MIL-PRF-28750/9C
AMENDMENT 3
15 December 2000
AMENDMENT 2
29 February 2000

PERFORMANCE SPECIFICATION SHEET

RELAY, SOLID-STATE, HERMETICALLY SEALED, CLASS II, OPTICALLY ISOLATED,
ZERO VOLTAGE TURN-ON, 1 AMPERE (2 AMPERES WITH HEAT SINK),
400 HZ, POWER SWITCHING, SPST (N.O.)

This amendment forms a part of MIL-PRF-28750/9C dated 1 February 1999, and is approved for use by all Departments and Agencies of the Department of Defense.

FIGURE 5. Broadband conducted emissions."

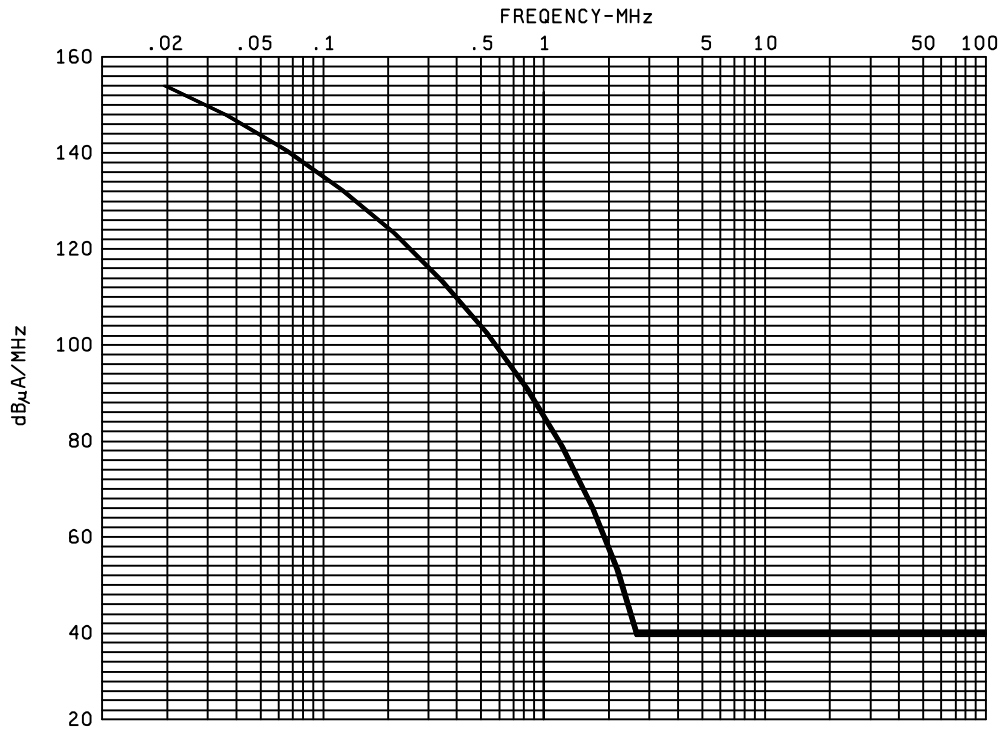
* Add a figure 5:

* Add a paragraph: “Electromagnetic interference: Maximum broadband conducted emission on power lines with 115 V ac, 400 Hz, 1.0 ampere resistive load during steady state and switching conditions (see figure 5).”
